NPF-38-08

DESCRIPTION AND SAFETY ANALYSIS  
OF PROPOSED CHANGE NPF-38-08

This is a request to modify the Technical Specifications to remove the Core Protection Calculator (CPC) Type I and Type II Addressable Constants, as approved by the NRC Core Performance Branch in April, 1985.

DESCRIPTION AND SAFETY ANALYSIS  
OF PROPOSED CHANGE NPF-38-09

FIGURE 3.2-2

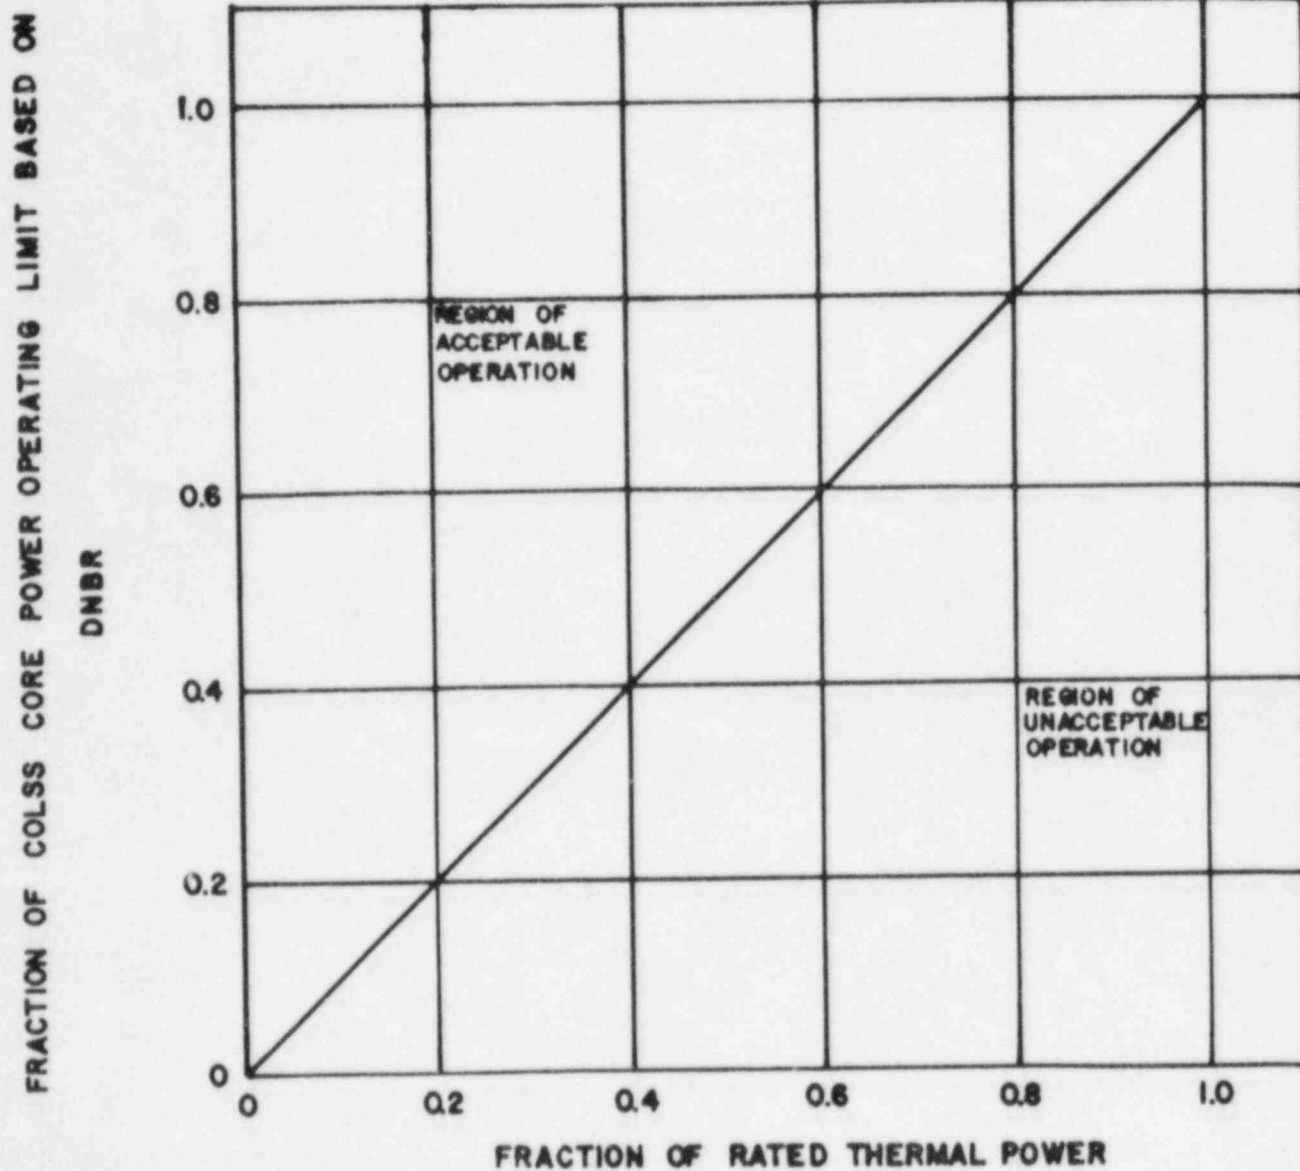
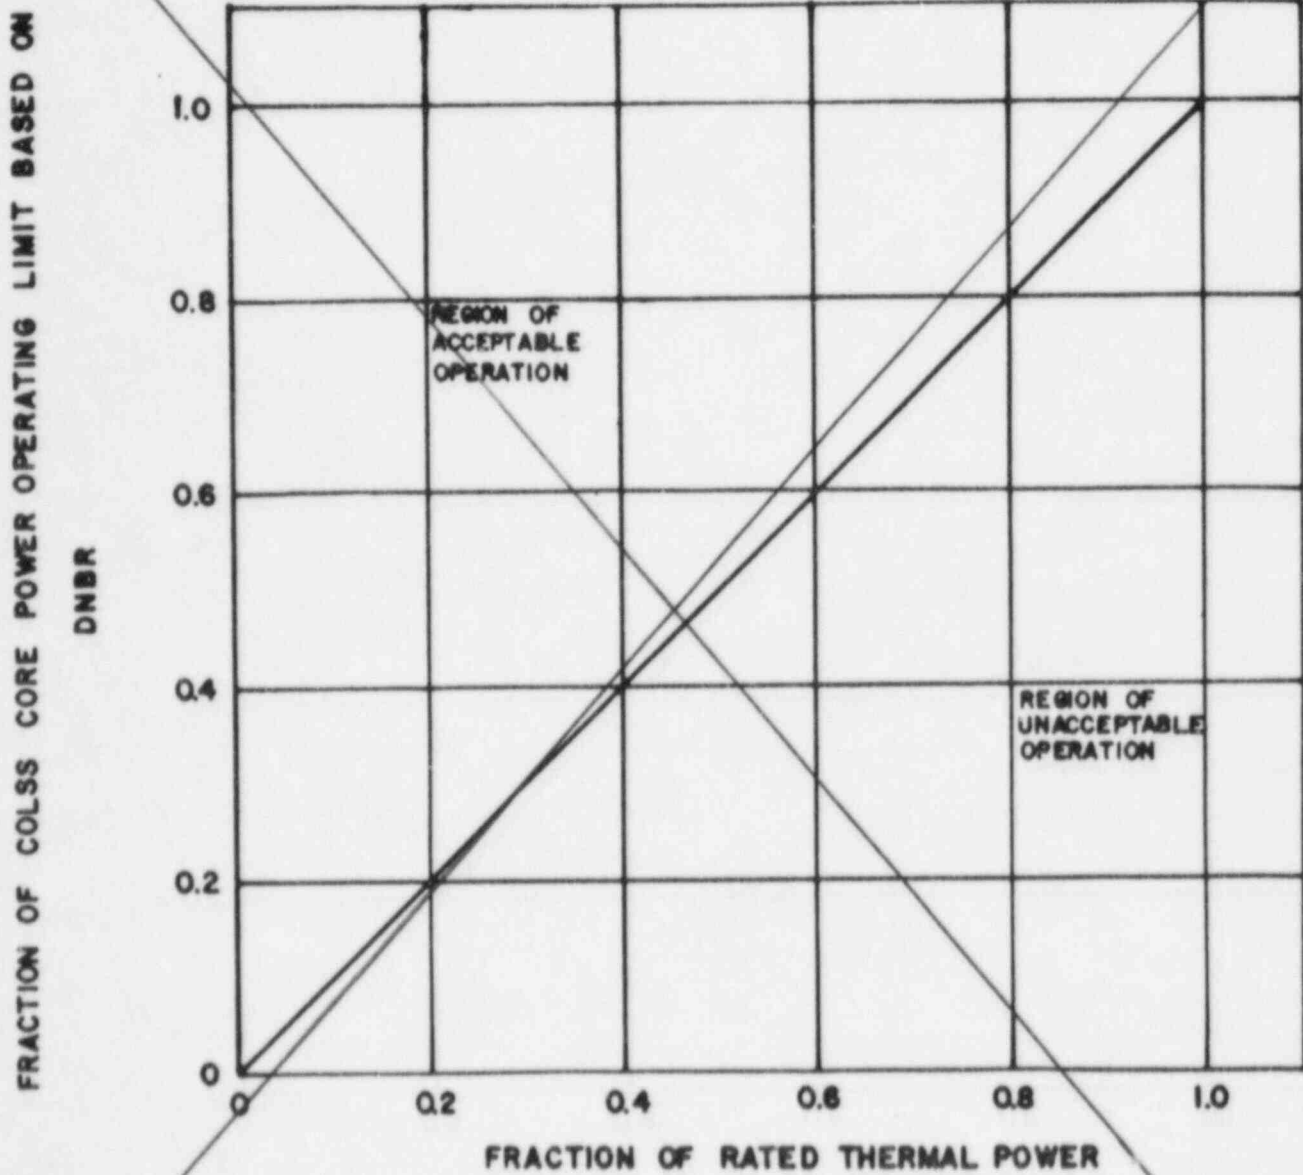
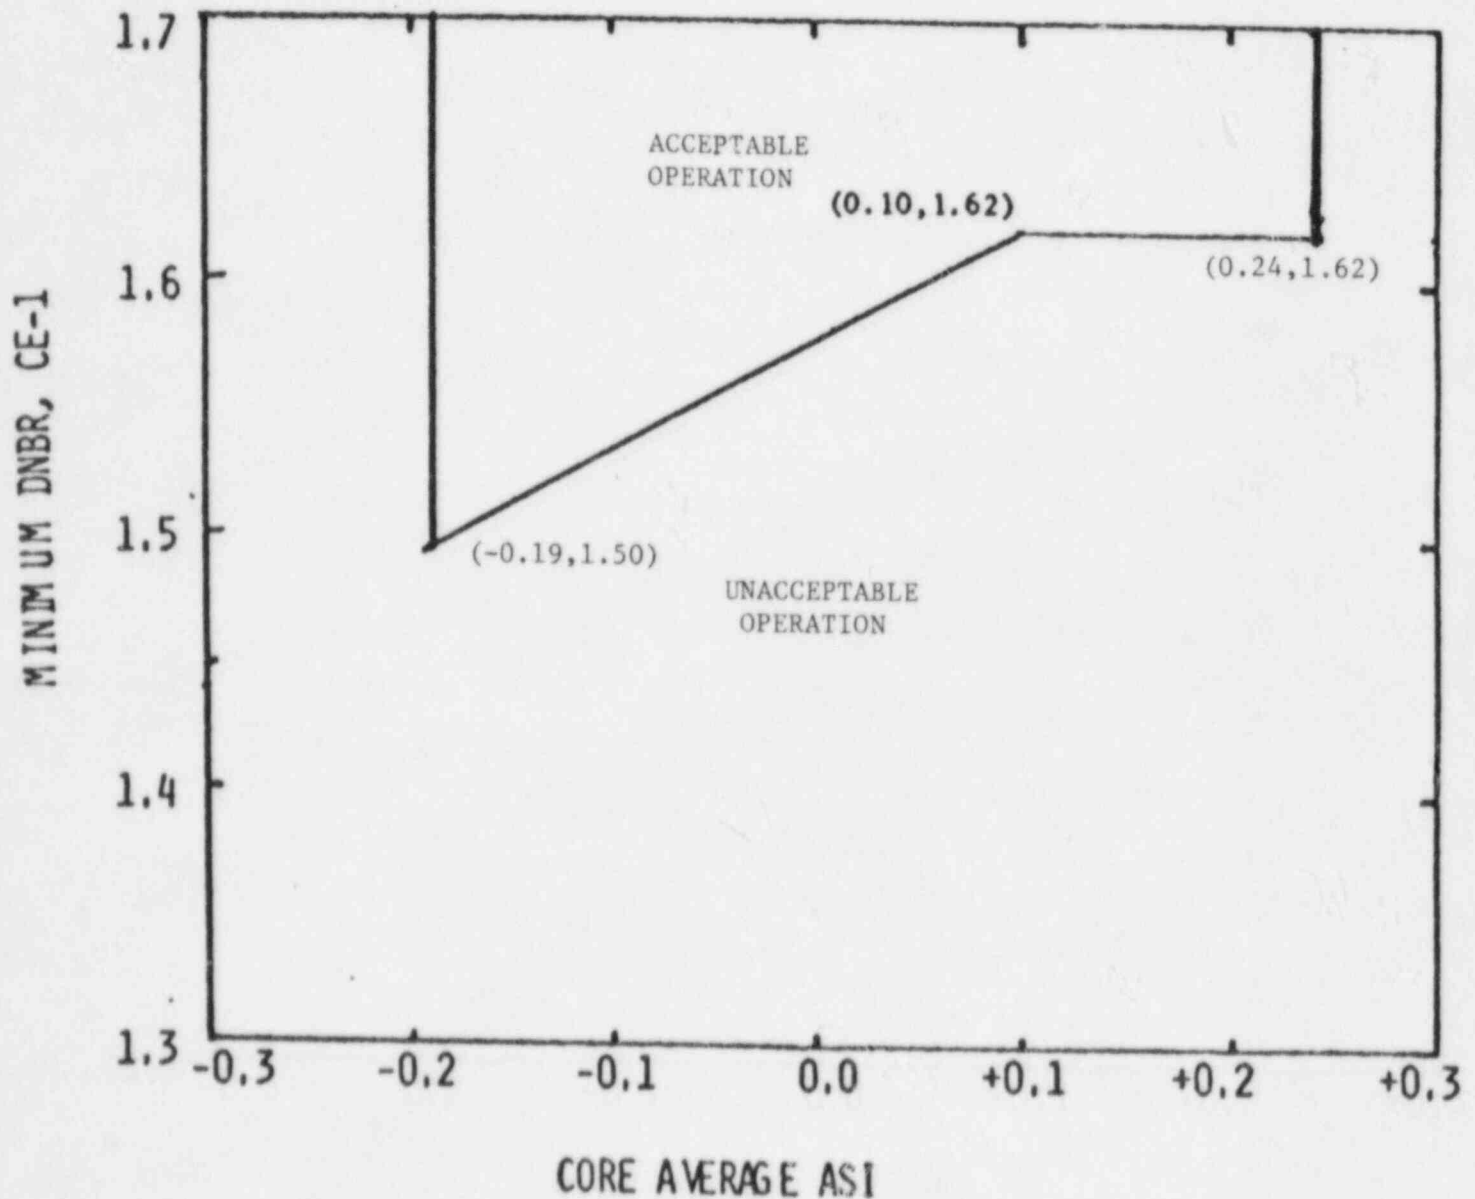
The proposed change will revise Technical Specifications 3.2.1, "Linear Heat Rate", 3.2.4, "DNBR Margin", 3.2.7, "Axial Shape Index", and the associated Bases. The proposed change will also add Figure 3.2-1a "Allowable Peak Linear Heat Rate vs Tc for COLSS Out-of-Service"; delete Figure 3.2-2 "DNBR Margin Operating Limit Based on COLSS" and replace it with "DNBR Margin Operating Limit Based on CPC's (COLSS Out-of-Service, CEACs Operable)"; Revise Figure 3.2-3 "DNBR Margin Operating Limit Based on CPC's (COLSS Out-of-Service, CEAC Inoperable)"; and revise Action 6.b.1 of Table 3.3-1.

In this case the proposed change described above is similar to Example (vi) in that revising Technical Specifications 3.2.1, 3.2.4 and 3.2.7; revising Figure 3.2.3 and Action 6.6.1 of Table 3.3-1; replacing Figure 3.2-2; and revising the associated Bases is clearly within all acceptable criteria specified by the NRC for digital plant protection systems in general and the CPC in particular. Additionally, the changes provide for less impact than allowed by Example (vi) because no safety margins are reduced.

1. COLSS calculated core power exceeding the appropriate COLSS calculated power operating limit; or
2. With COLSS out of service, operation outside the region of acceptable operation of Figure 3.2-2 or 3.2-3, as applicable;

FIGURE 3.2-1a.

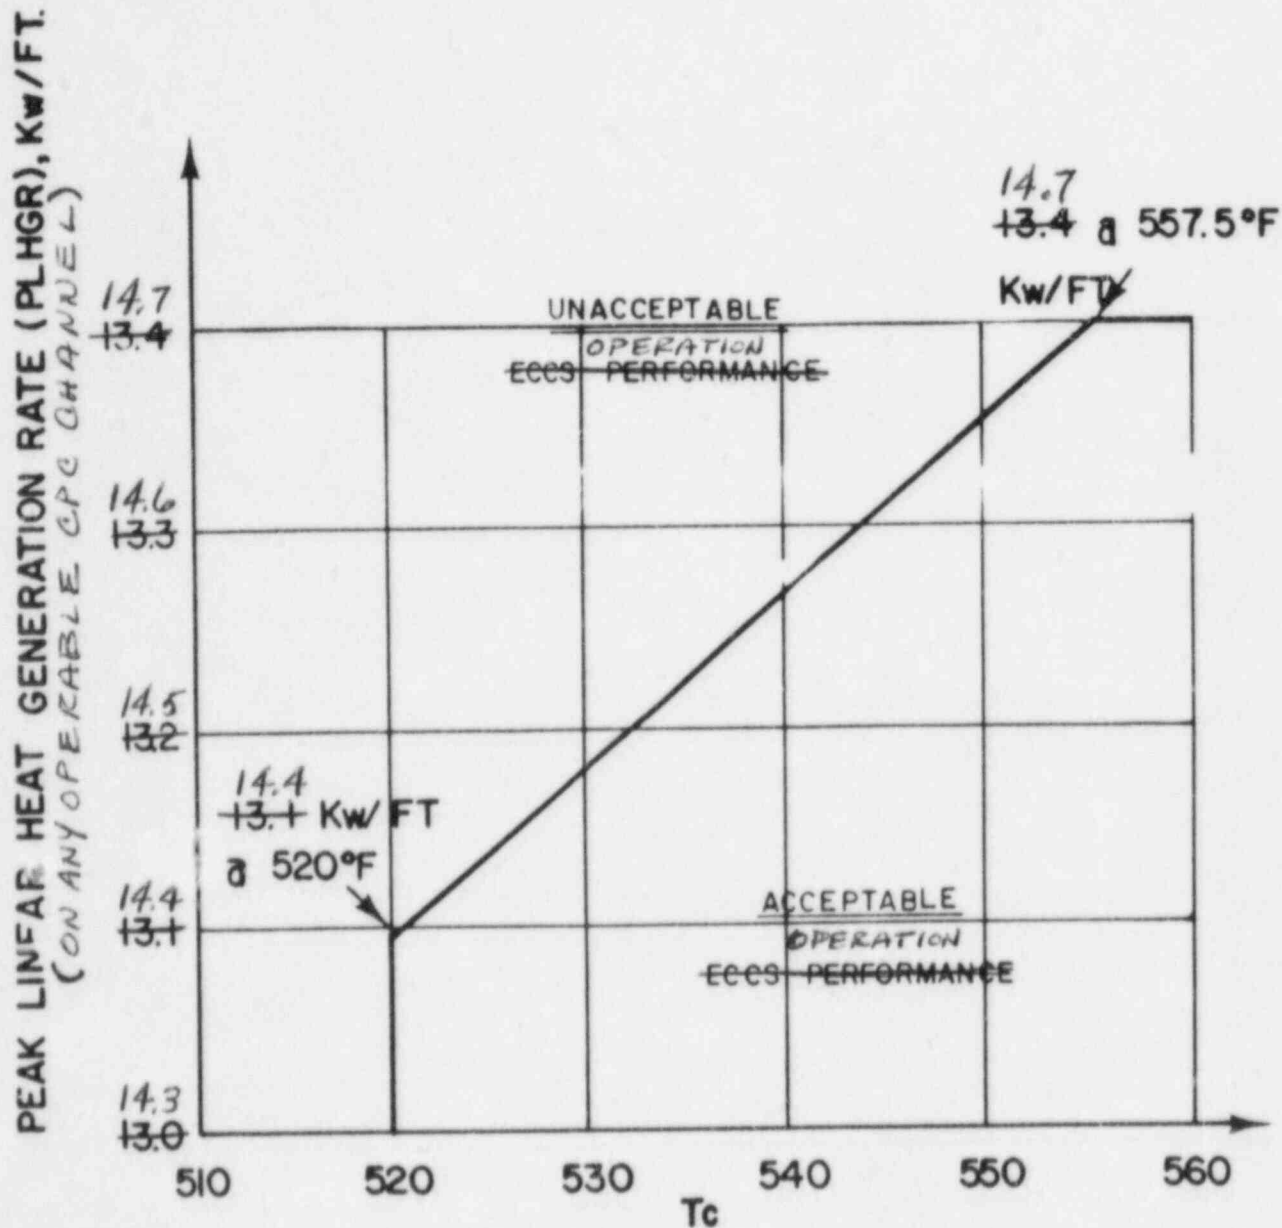
The additional uncertainty terms included in the CPC's for transient protection are credited in Figure 3.2-1a since this curve is intended to monitor the LCO only during steady state operation.

- a. Maintaining COLSS calculated core power less than or equal to COLSS calculated core power operating limit based on linear heat rate (when COLSS is in service); or
- b. Operating within the region of acceptable operation of Figure 3.2.1a using any operable CPC channel (when COLSS is out of service and either one or both CEACs is operable).
- c. Automatically by CPC (when COLSS is out of service and neither CEAC is operable).

1. COLSS calculated core power exceeding COLSS calculated core power operating limit based on linear heat rate; or
2. When COLSS is out of service, operation outside the region of acceptable operation in Figure 3.2.1a;
